# UNITED STATES PATENT AND TRADEMARK OFFICE

APPLICATION NO.	FILING DATE	FIRST NAMED INVENTOR	ATTORNEY DOCKET NO.	CONFIRMATION NO.
10/661,793	09/12/2003	Chi-An Kao	TS01-1037	8353
8933	7590	09/19/2005	EXAMINER	
DUANE MORRIS, LLP			NGUYEN, KHIEM D	
IP DEPARTMENT			ART UNIT	PAPER NUMBER
30 SOUTH 17TH STREET				
PHILADELPHIA, PA 19103-4196			2823	
DATE MAILED: 09/19/2005

<b>Office Action Summary</b>	Application No.	Applicant(s)
	10/661,793	KAO ET AL.
	Examiner Khiem D. Nguyen	Art Unit 2823

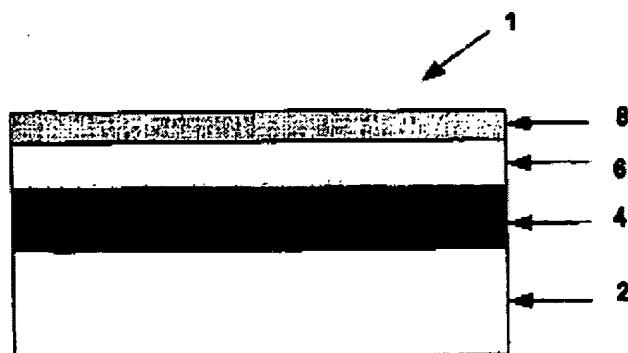
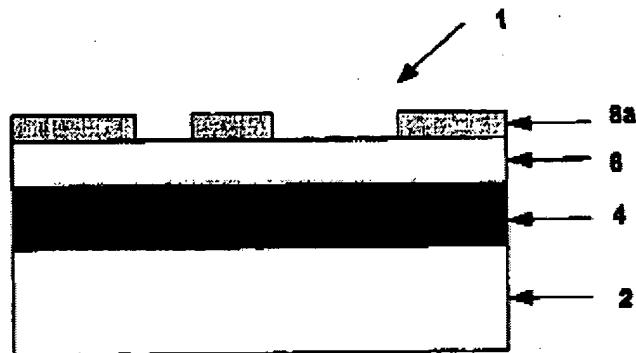
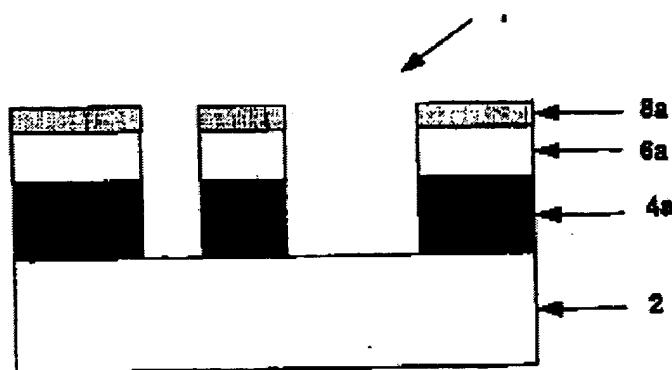
means for creating an opening (unlabeled) through a layer of etch resist material 8a provided over the surface of a layer of insulating material 6 having been deposited over the surface of a substrate 2 (pages 6-7, paragraph [0071] and FIGS. 1-2);

means for creating an opening (unlabeled) through the layer of insulation material 6, whereby a diameter of the layer of insulation material is dependent on a diameter of the opening created through the layer of etch resist material (pages 6-7, paragraph [0071] and FIGS. 1-2); and

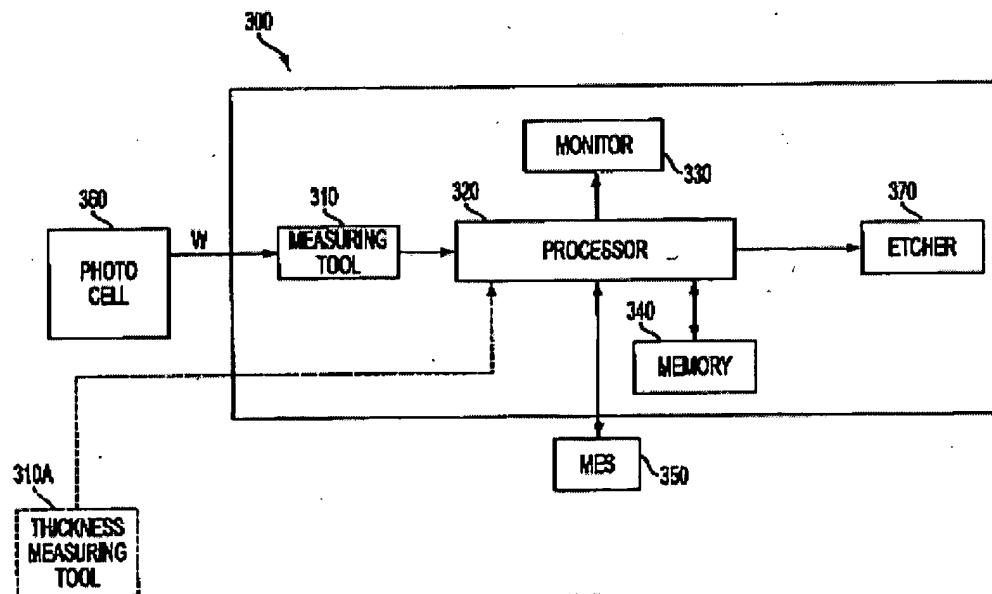
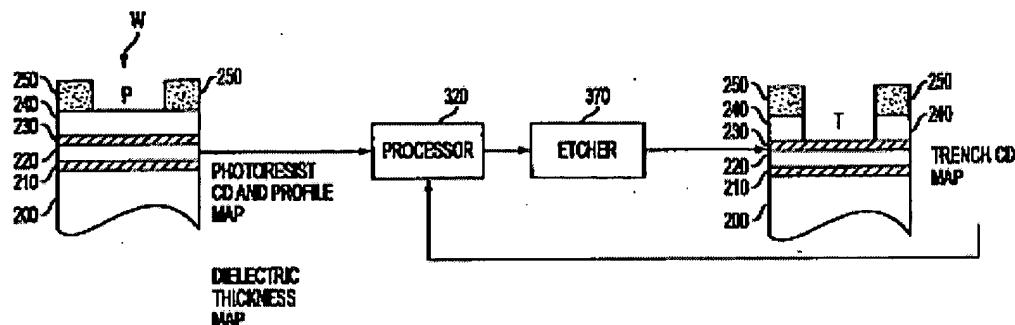
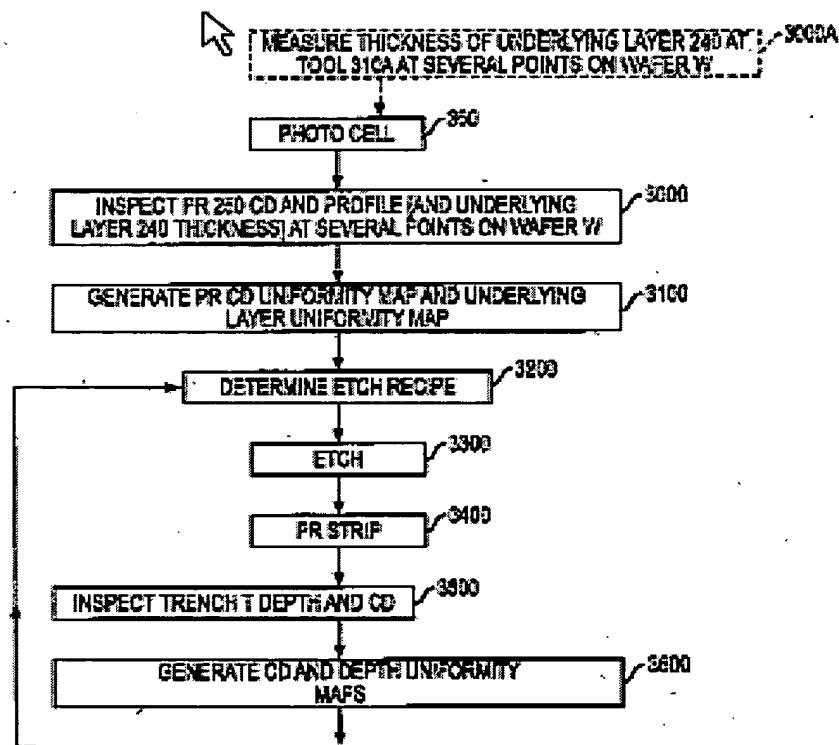
means for creating an opening (unlabeled) through a layer of etch resist material 250 provided over the surface of a layer of insulating material 240 having been deposited over the surface of a substrate 200 (pages 3-4, paragraphs [0032]-[0034] and FIGS. 1-3);

means for creating an opening (unlabeled) through the layer of insulation material 240, whereby a diameter of the layer of insulation material is dependent on a diameter of

the opening created through the layer of etch resist material (pages 3-4, paragraphs [0032]-[0034] and FIGS. 1-3); and

In response to Applicants' contention that Lymberopoulos does not teach or suggest the claimed feature of "means, including a feedback mechanism, for assuring that the opening created through the layer of etch resist material is within design specification", Examiner respectfully disagrees. Applicants are directed to FIG. 3, where Lymberopoulos disclosed the step of inspect the trench depth and critical dimension CD 3500 using the measuring tool 310 as disclosed in FIG. 1. This processes as disclosed by

Lymberopoulos inherently assuring that the opening created through the layer of etch resist material 250 and the insulation material 240 is within design specification (page 4, paragraphs [0035]-[0036]).
